# PRODUCT / PROCESS CHANGE NOTIFICATION

PCN-000710

Additional Source to Support Production Assembly and Final Test from Carsem Suzhou to Carsem Malaysia

**PCN No. 000710**  
**Qualification of Carsem Ipoh for TS3001X-M0XXQFNR products**

### Assembly Process Flow Comparison for CarsemSZ (Old) vs. CarsemIPH (New)

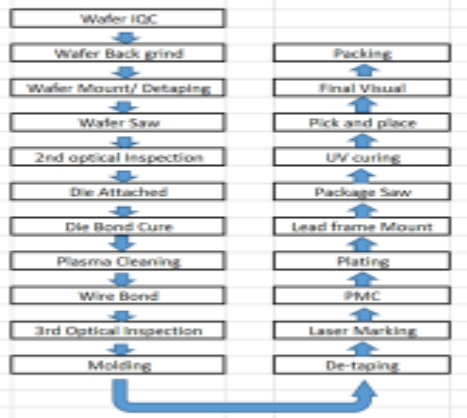
- No major Change in manufacturing Flow for both Assembly site CarsemSZ versus CarsemIPH except additional process step for plasma cleaning before mold for CarsemIPH.

**BOM Comparison CarsemSZ (Old) vs CarsemIPH (New)**

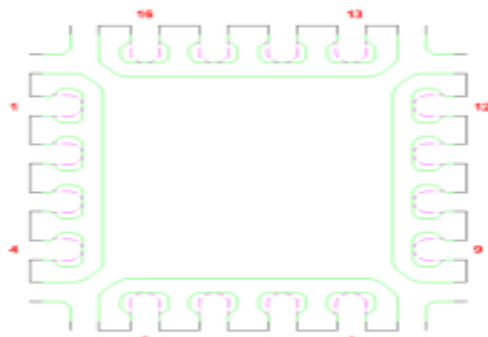
- BOM for both supplier CarsemSZ and CarsemIPH are no difference.

**Bonding Layout (CarsemSZ vs  
CarsemIPH)**

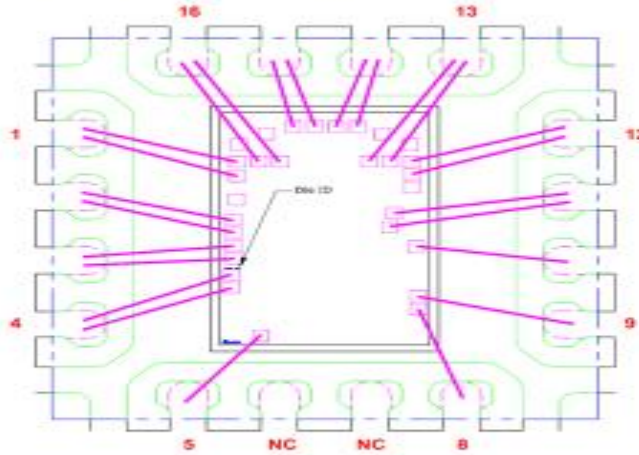
**No Change in Bonding Layout.**
